DART AEROSPACE LTD	Work Order: 71988
Description: Crosstube Assembly (206L High Fwd)	Part Number: D206-667-143
Inspection Dwg: D206-667-143 Rev: C	Page 1 of 1

DRAWING NO. D206-667-143	TITLE CROSSTUBE ASS'Y (206L HIGH FWD)	REV. C	DART AEROSPACE LTD ENGINEERING ORDER		D.E.O. NO. D206-667-143-C-1	SHEET NO. SHEET 1 OF 1	SCALE NTS
DRAWN 92	CHECKED ASS	MFG. APPR. [Signature]	APPROVED [Signature]		DE APPR. [Signature]		
DATE 11.07.15	DATE 11.07.20	DATE 11.07.21	DATE 11/07/21		DATE 11.07.21

REPLACE MAGNOBOND WITH PROSEAL

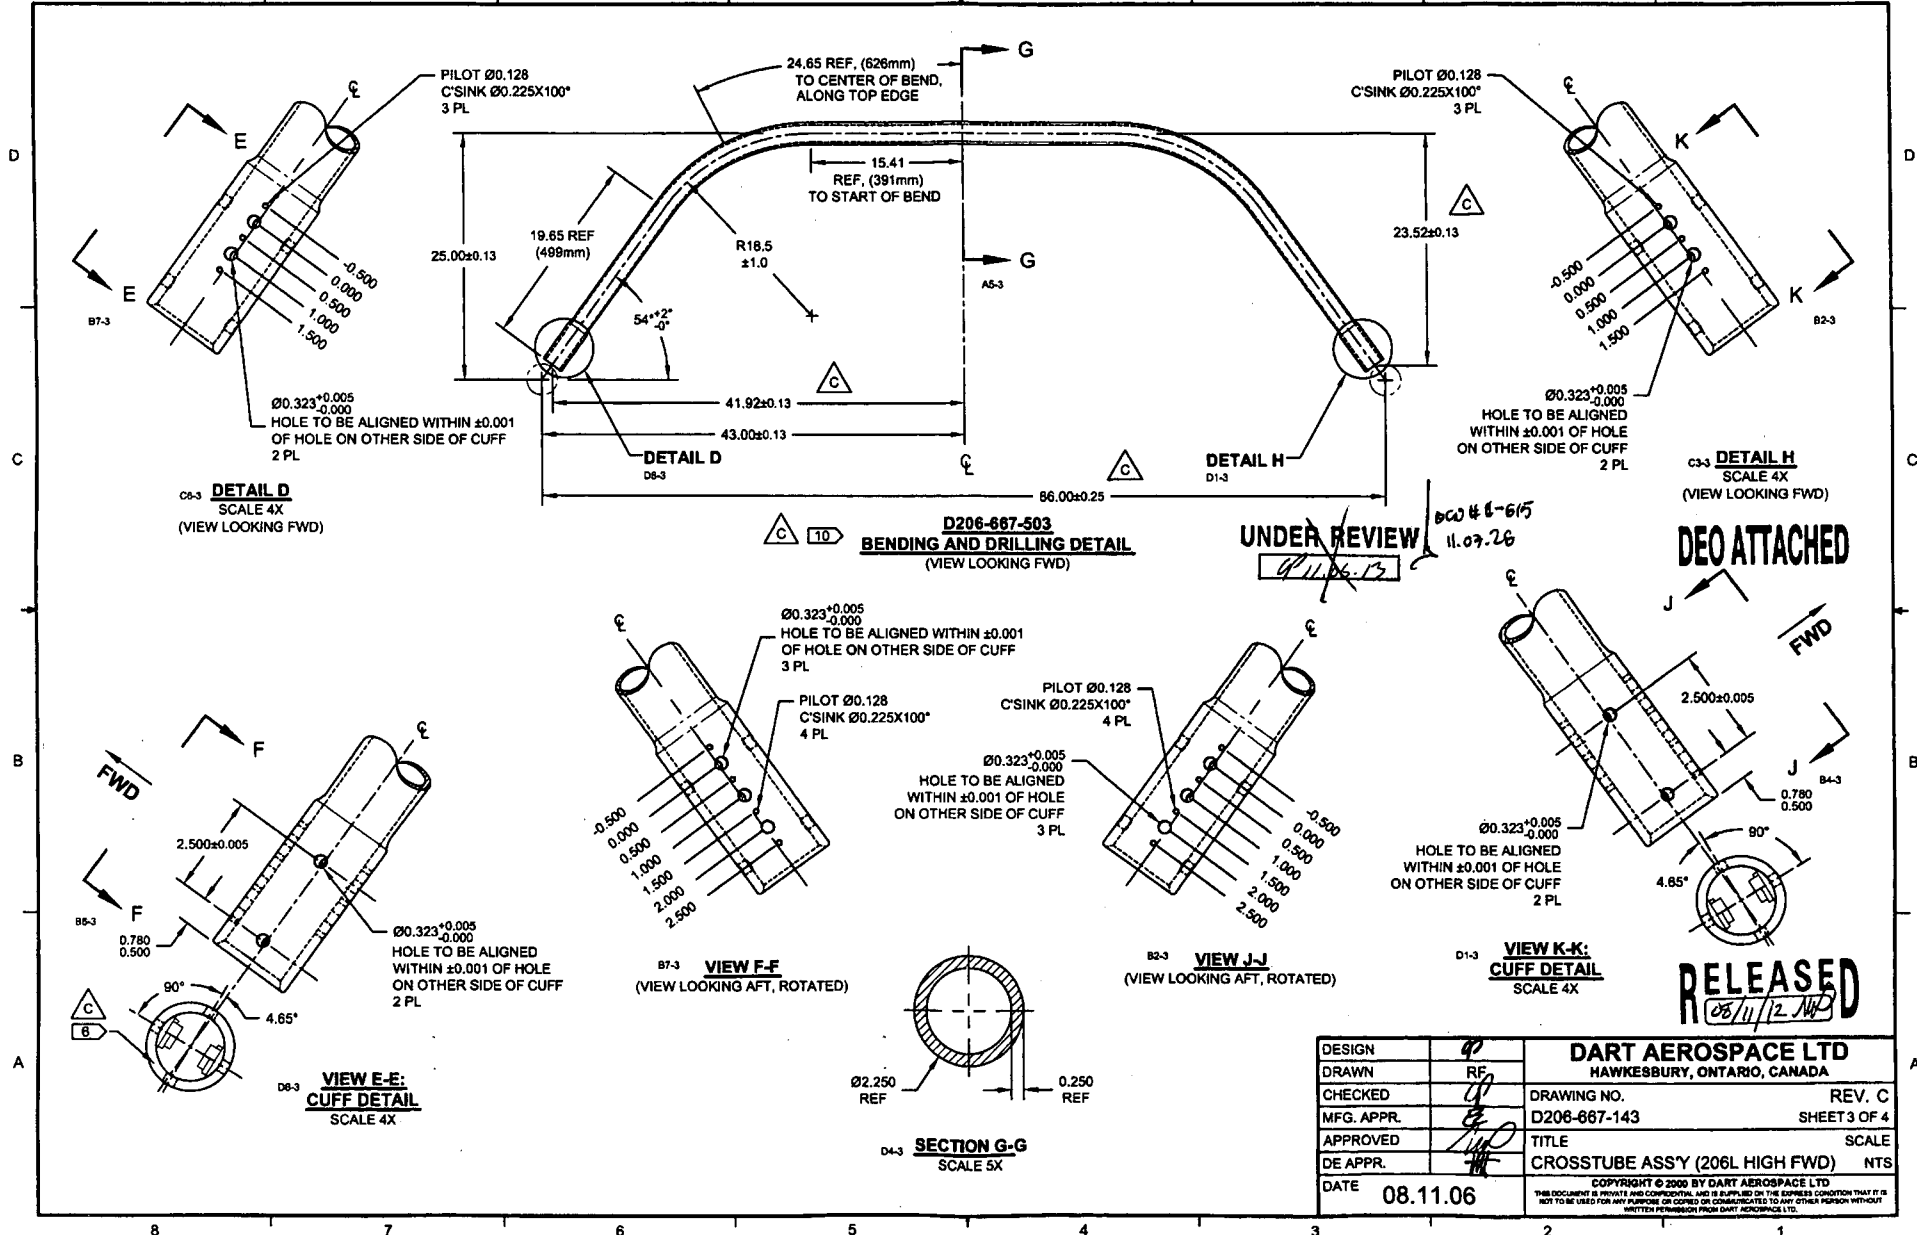
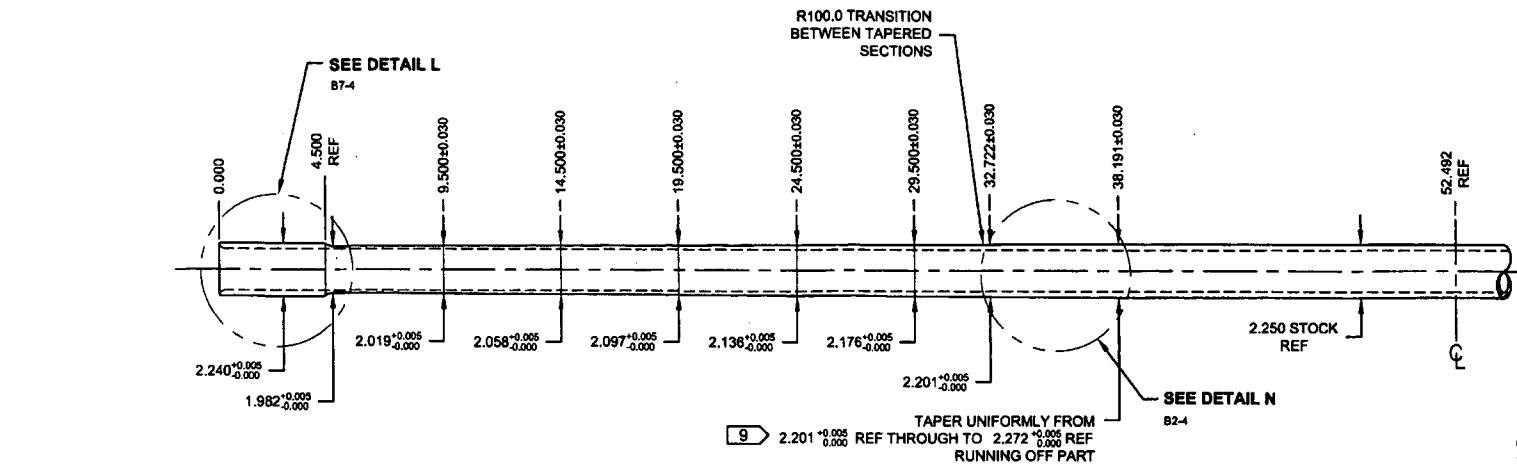
Item	Qty -143	Part Number	Description
9	A/R	PROSEAL 890 B-2	SEALANT, AMS-S-8802 CLASS B-2

9	A/R	MAGNOBOND 6398	ROCKWELL SPECIFICATION RBO-120-023 ADHESIVE (TEXTRON/BELL SPEC. 299-947-100, TYPE II, CLASS 2 ADHESIVE)
---	-----	----------------	---

NOTE 12 & 15, SHEET 1 IS AMENDED AS FOLLOWS:

- 12) INSTALL D2891-1 SUPPORT USING 0.03" TO 0.06" THICK LAYER OF MAGNOBOND 6398 PER QSI 015. LET CURE FOR 12 HOURS AFTER INSTALLATION AND PRIOR TO PACKAGING.
- 15) TORQUE CLAMPS 80 TO 100 IN-LB. ENSURE AT LEAST 1.5 THREADS SHOWING IN SAFETY AND THAT NUT HAS NOT BOTTOMED-OUT AFTER TORQUING.

- 12) TO INSTALL D2891-1 SUPPORT: ABRASE MATING SURFACE OF SUPPORT AND CROSSTUBE WITH 180-GRIT SANDPAPER AND REMOVE RESIDUE WITH MEK (OR EQUIVALENT). APPLY A 0.04" TO 0.07" THICK LAYER OF PROSEAL 890 CLASS B-2 (OR AMS-S-8802 CLASS B-2) SEALANT TO MATING SURFACE OF SUPPORT.
- 15) TORQUE CLAMPS 80 TO 100 IN-LB. ENSURE AT LEAST 1.5 THREADS SHOWING IN SAFETY AND THAT NUT HAS NOT BOTTOMED-OUT AFTER TORQUING. **PRIOR TO PACKAGING, RE-CHECK TORQUE ON CLAMPS AFTER PROSEAL 890 SEALANT HAS CURED FOR 72 HOURS.**
